**TO:** MASTER PLAN AND ZONING COMMITTEE  
**FROM:** SRI RAVALI KOMARAGIRI, PLANNER  
**THRU:** BARBARA MCBETH, *AICP*, CITY PLANNER  
**SUBJECT:** CONSIDERATION OF PRO CONCEPT PLAN FOR NOVAPLEX  
**DATE:** SEPTEMBER 05, 2019

The petitioner, BC Novaplex LLC, is requesting a Zoning Map amendment for 22 acre property on the west side of Haggerty Road, north of Twelve Mile Road (Section 12) from Office Service Technology (OST) to High-Density Multiple Family (RM-2) with a Planned Rezoning Overlay. The applicant is proposing to develop a 332 unit multiple-family residential development. The development consists of two attached town style buildings and eight apartment style building. All units are three stories tall at its average grade. The development is a private street network with two entrances off of Haggerty Road.

Rezoning Request from OST Office Service Technology to High-Density Multiple Family RM-2 with a Planned Rezoning Overlay

**Figure 1.** City of Novi Regulated Wetland & Woodland Map (approximate project boundary shown in red). Regulated Woodland areas are shown in green and Regulated Wetland areas are shown in blue).

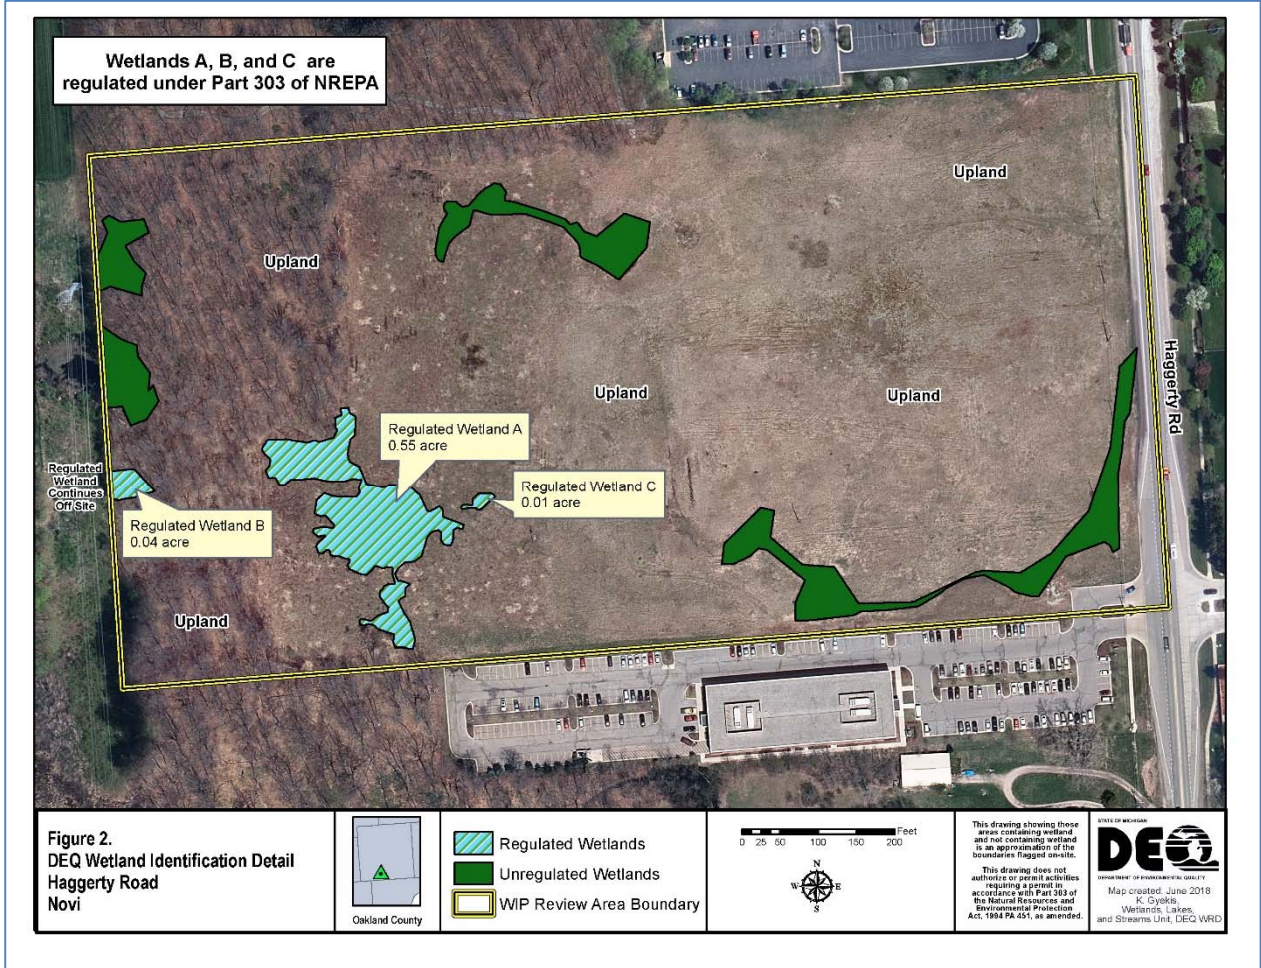
ECT’s in-office review of available materials included the City of Novi Regulated Wetland and Woodland map, USGS topographic quadrangle map, NRCS soils map, USFWS National Wetland Inventory map, and historical aerial photographs. The site includes areas indicated as City-regulated wetland on the official City of Novi Regulated Wetland and Woodland Map (see Figure 1).

ECT visited the site most recently on August 20, 2019 for the purpose of a wetland boundary verification. The focus of the inspection was to review site conditions in order to determine whether on-site wetlands are considered regulated under the City of Novi’s Wetland and Watercourse Protection Ordinance. Wetland boundary flagging was in place in some areas of the site at the time of our inspection and not present in others. ECT concurs with the seven (7) wetland areas (Wetlands A, B, C, D, E, F, and G) indicated on the MDEQ’s Wetland Identification Detail figure (Figure 2, attached). The current Plan appears to show most of the wetland areas that have been delineated on site by the applicant’s wetland as well as by MDEQ during their June 7, 2018 WIP review.

**Figure 1. City of Novi Regulated Wetland Boundaries Map.** Regulated wetland boundaries are shown in blue and regulated woodland areas are indicated in green. The approximate property boundary is shown in red.

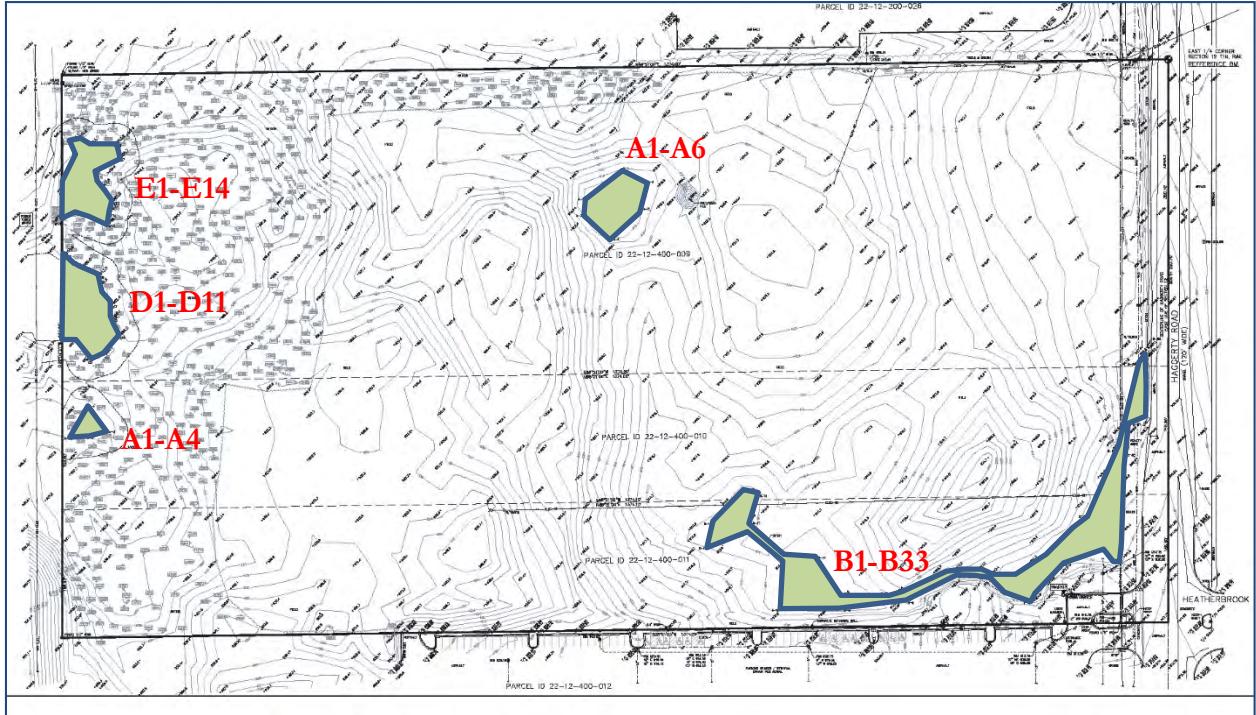
ECT's in-office review of available materials included the City of Novi Regulated Wetland and Watercourse map, USGS topographic quadrangle map, NRCS soils map, USFWS National Wetland Inventory map, and historical aerial photographs. The site includes several wetland areas that are indicated as City-regulated on the official City of Novi Regulated Wetland and Watercourse Map (see Figure 1).

ECT has evaluated the on-site wetlands and believes that they are all considered to be essential/regulated by the City of Novi as they meet one or more of the essentiality criteria (i.e., functions and values) outlined in the City of Novi Wetland and Watercourse Protection Ordinance (listed above). Specifically, the wetlands provide either flood and storm control or wildlife habitat. As noted, the wetlands appear to accurately flagged in the field and appear to be generally indicated accurately on the *Topographic Survey* provided by the applicant (Figure 2, attached). The dominant vegetation within Wetland B consisted of mainly common reed (*Phragmites australis*); an invasive species of vegetation.

**Figure 1.** City of Novi Regulated Wetland & Woodland Map (approximate project boundary shown in red). Regulated Woodland areas are shown in green and Regulated Wetland areas are shown in blue.

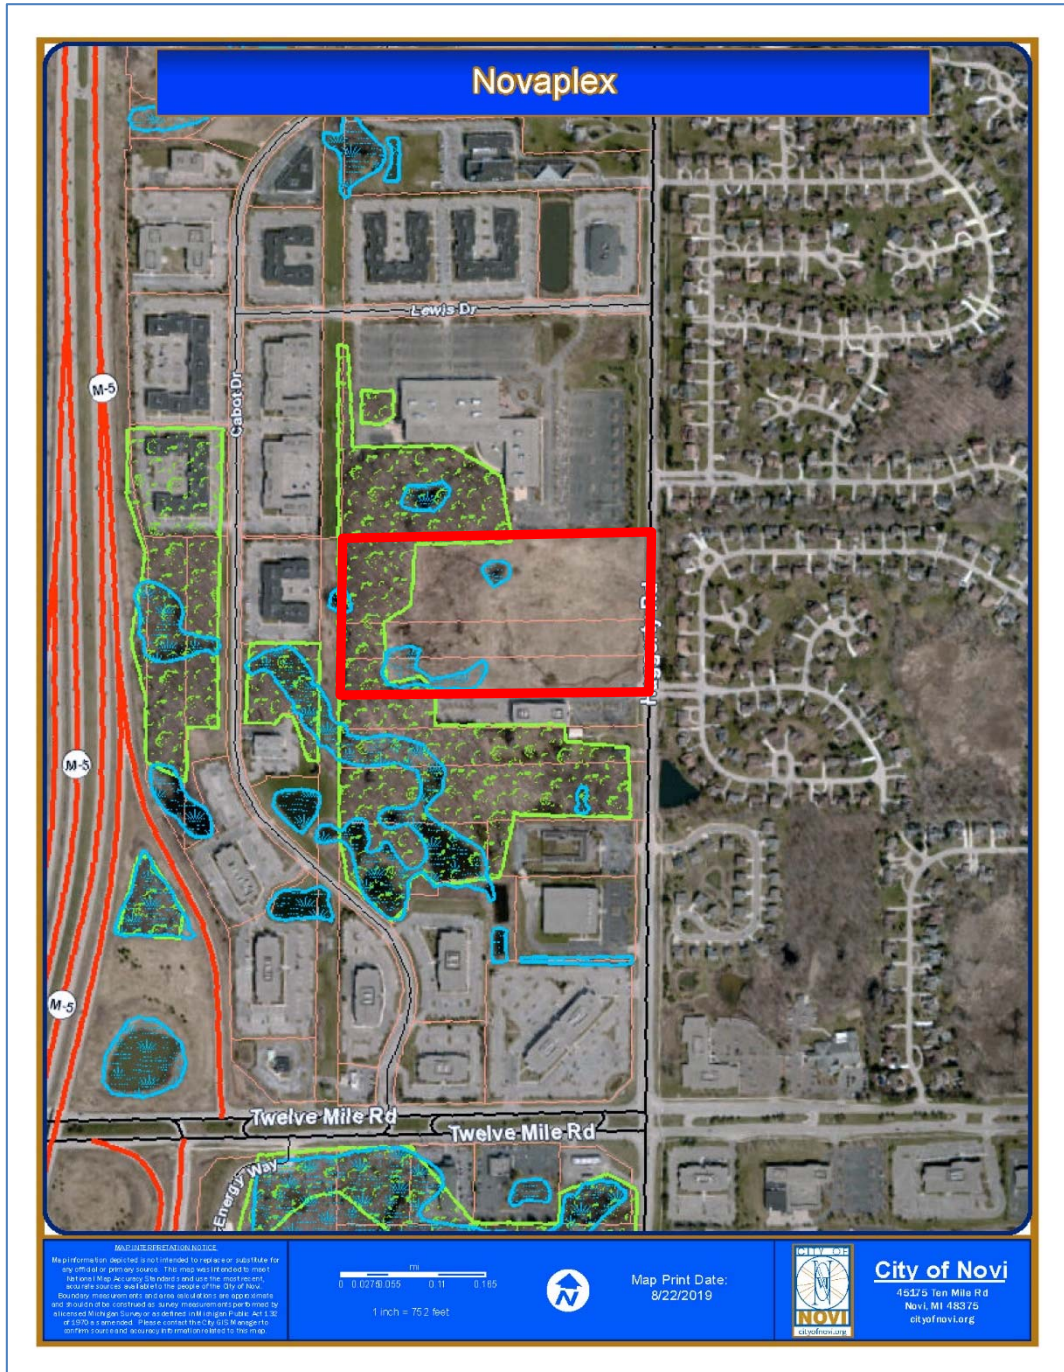
ECT has reviewed the City of Novi Official Woodlands Map and completed an onsite Woodland Evaluation on August 20, 2019. ECT's in-office review of available materials included the City of Novi Regulated Woodland map and other available mapping. The subject property does include areas indicated as City-regulated woodland on the official City of Novi Regulated Wetland and Woodland Map (see Figure 1). The majority of the site has been previously cleared of trees, however, as shown on the *Topographic Survey* (Sheet C-1.0), a forested buffer remains along the western portion and a section of the northwester edge of this parcel. Sections of this remaining forested area appear to exceed 300 lineal feet in width. The remaining woodland areas consists of a high-quality beech-sugar maple forest that has a dense canopy dominated by beech and sugar maple trees with some ash, basswood, oak, elm, black cherry, and walnut. Ironwood is a dominant understory tree along with beech and sugar maple saplings. Shrubs consist of predominantly spicebush with some witch-hazel, viburnum and common elderberry. Ground cover within this woodland includes creeping strawberry-bush, woodbine, Jack-in-the-pulpit, Solomon's seal, Christmas fern, bloodroot, beech drops, and mayapple.

DRAWING NUMBER:  
**L-1.0**

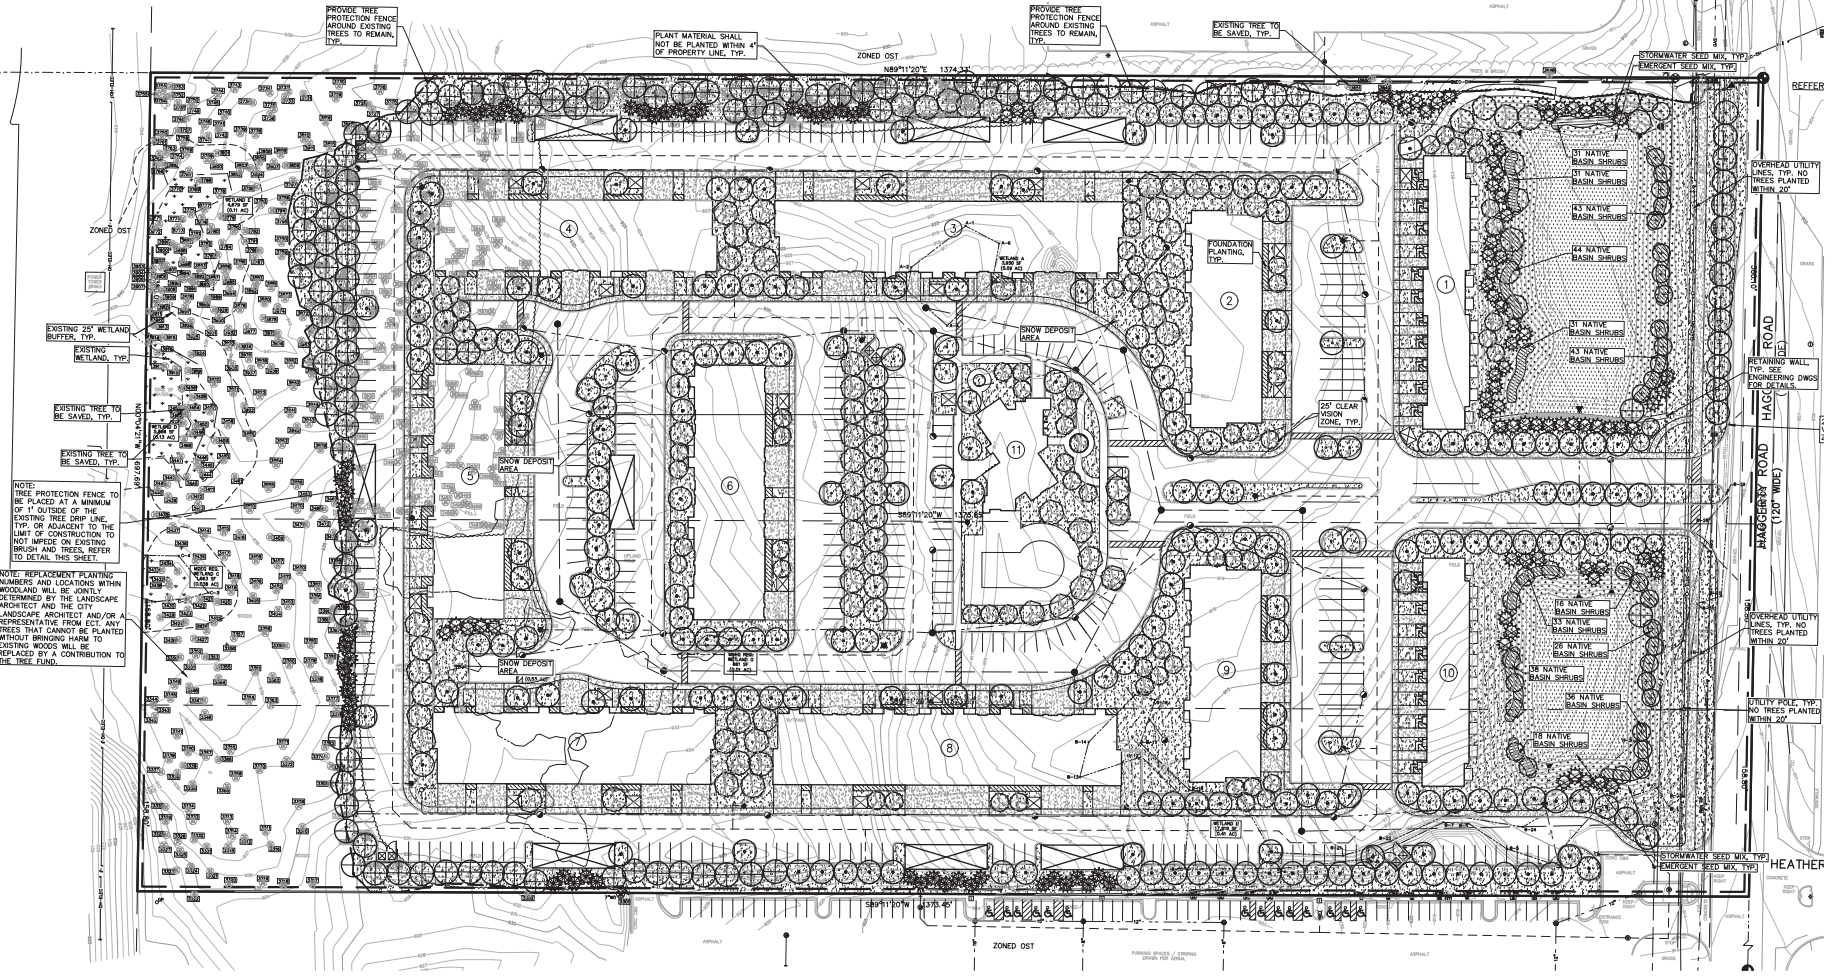
6. It should be noted that the *Preliminary Landscape Plan* (Sheet L-1.0) indicates that woodland replacement trees are to be planted within the regulated woodland areas remaining on the west side of the project site. The Plan also notes that replacement planting numbers and locations within the woodland will be jointly determined by the applicant's landscape architect and the City of Novi's Landscape architect. Any trees that cannot be planted without bringing harm to the existing woods will be replaced by a contribution to the City of Novi Tree Fund.

DRAWING NUMBER:  
**L-1.1**

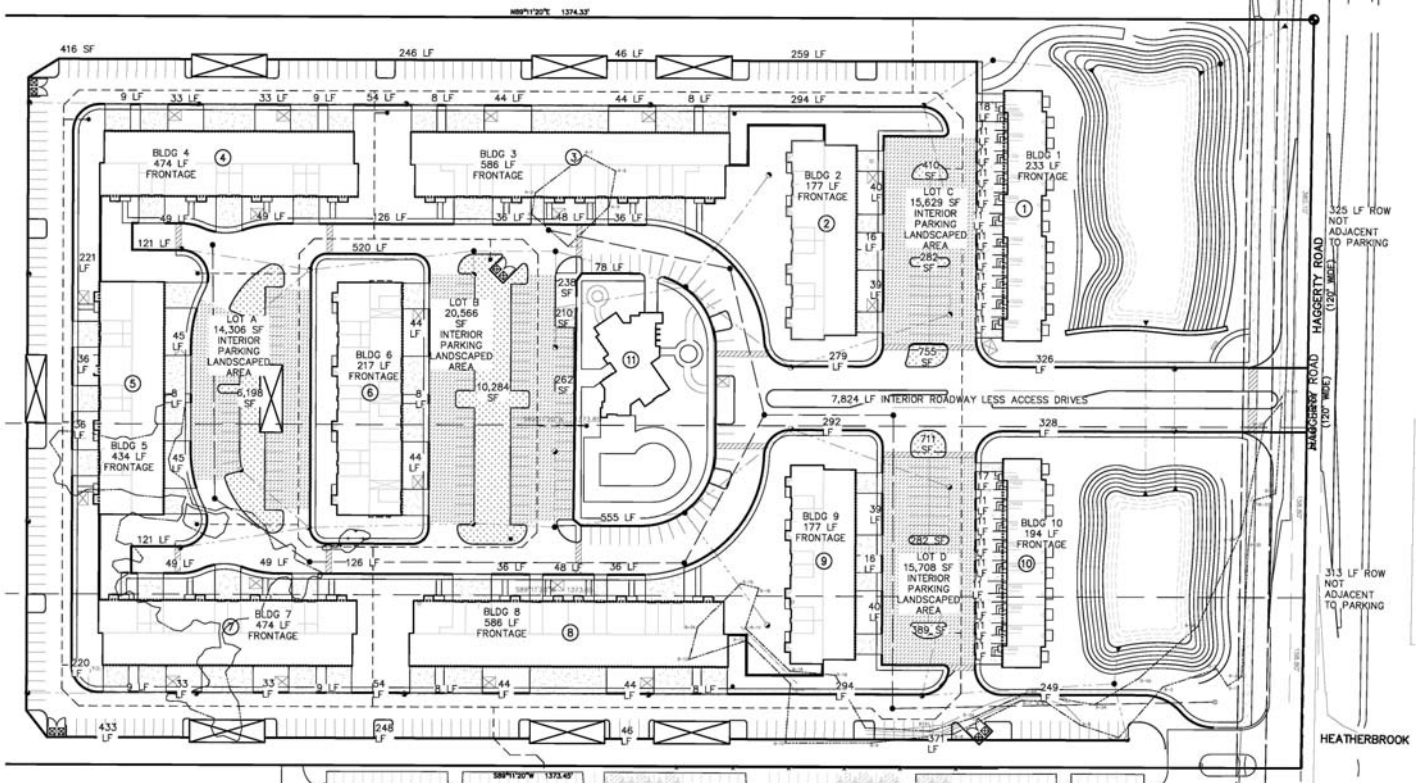
A *Woodland Summary* Table has been included on Sheet L-1.1 (*Prelim Landscape Calculations*). The Applicant has noted the following woodland impacts associated with the Plan:

7. The Plan appears to indicate that 140 Woodland Replacement Credits will be planted on-site and the remainder (343) shall be paid into the City of Novi Tree Fund. Sheet L-1.1 (*Prelim Landscape Calculations*) and Sheet L-1.0 (*Preliminary Landscape Plan*) contain some discrepancies. The *Preliminary Landscape Plan* appears to indicate a total of 104 deciduous replacement trees (104 Credits at 1-to-1 replacement ratio) and 54 evergreens (36 Credits at 1.5-to-1 replacement ratio) are to be planted. The information regarding replacements provided on the *Prelim Landscape Calculations* sheet differs slightly. Please review and revise the landscaping sheets to ensure that the woodland removal and proposed replacement information is consistent.

DRAWING NUMBER:  
**T-1.1**

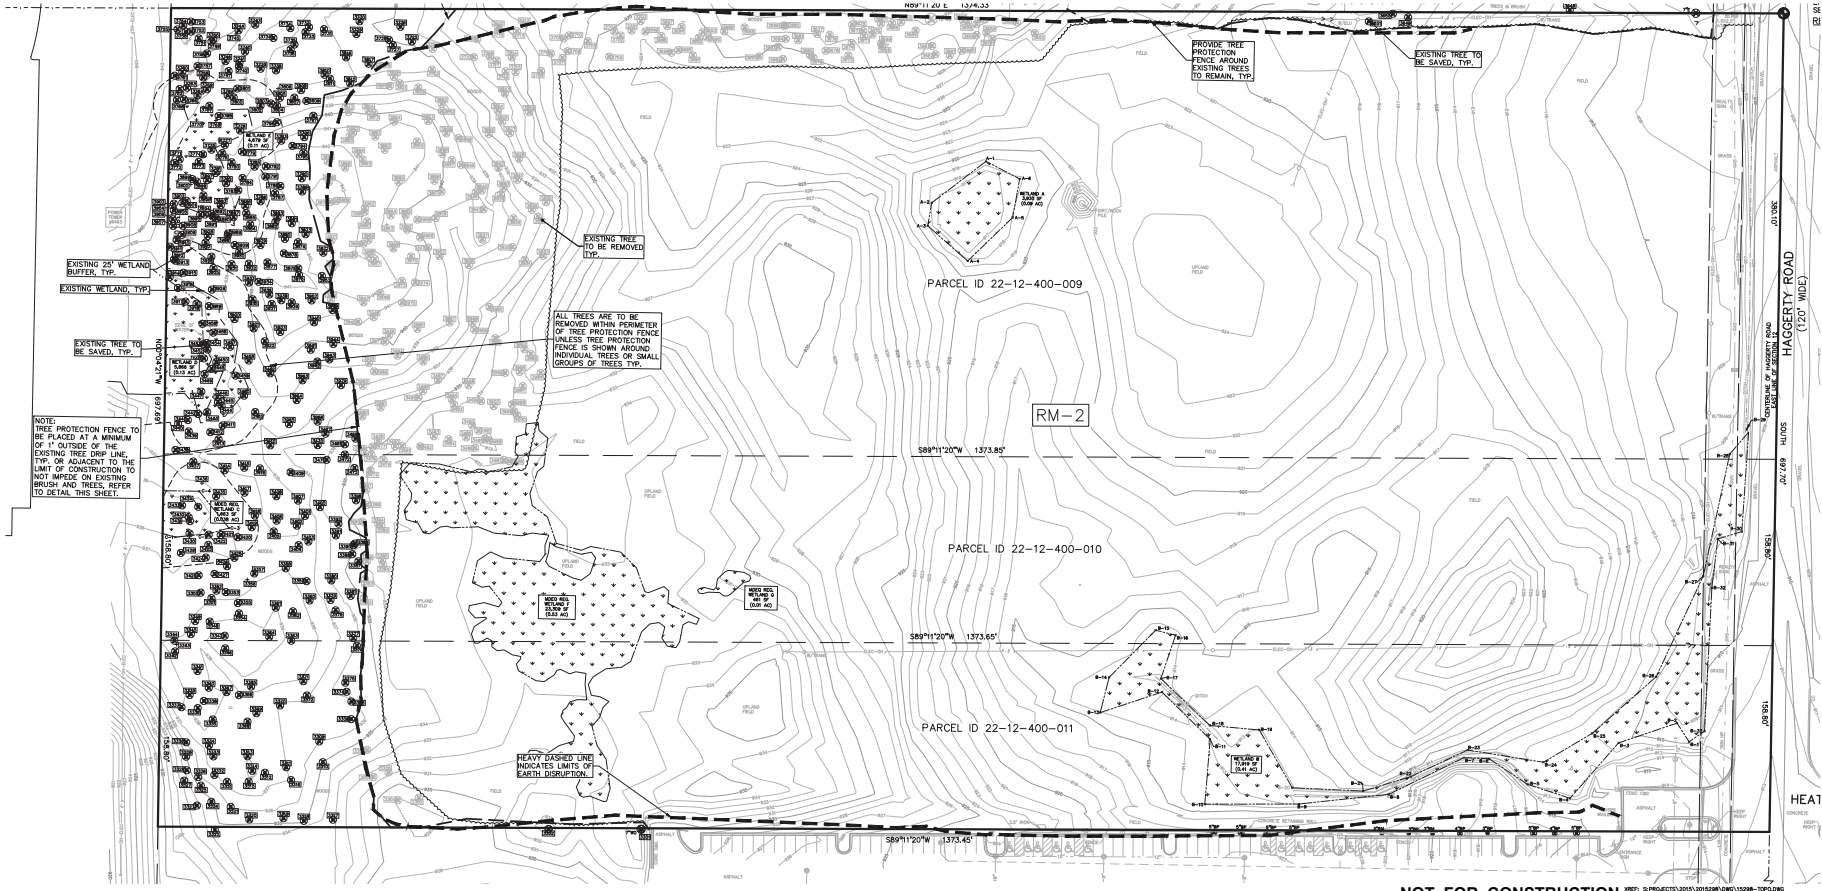
An existing tree survey and tree list has been provided. The Plan includes a surveyed tree list (*Prelim. Tree List*, Sheet T-1.1) that identifies tree tag numbers, diameter-at-breast-height (DBH), common/botanical name, condition, and required replacement credit quantities for all surveyed trees. The *Prelim Landscape Calculation* plan (Sheet L-1.1) includes a *Tree Replacement* Summary that lists the total woodland replacements credits that are required for the proposed tree removals.
